## Appendix B

### Emergency Preparedness Significance Determination Process

# Emergency Preparedness Significance Determination Process

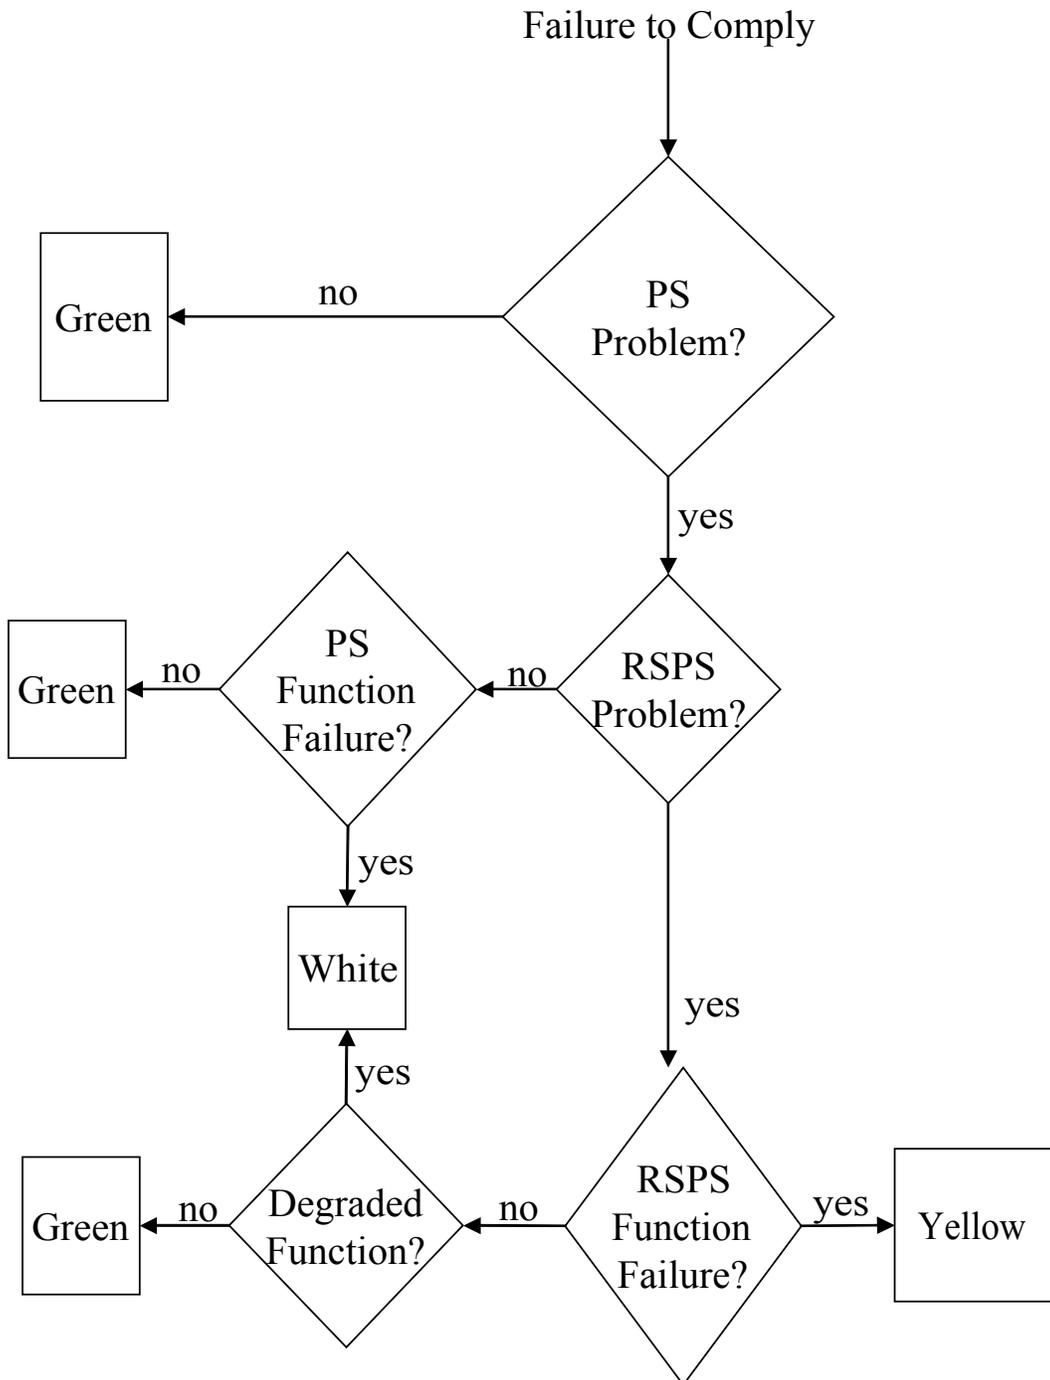
**Proposed Revision to EP SDP  
Failure to meet Regulatory Requirement  
(This line replaces left line sheet 1 Failure to meet Regulatory Requirement)**
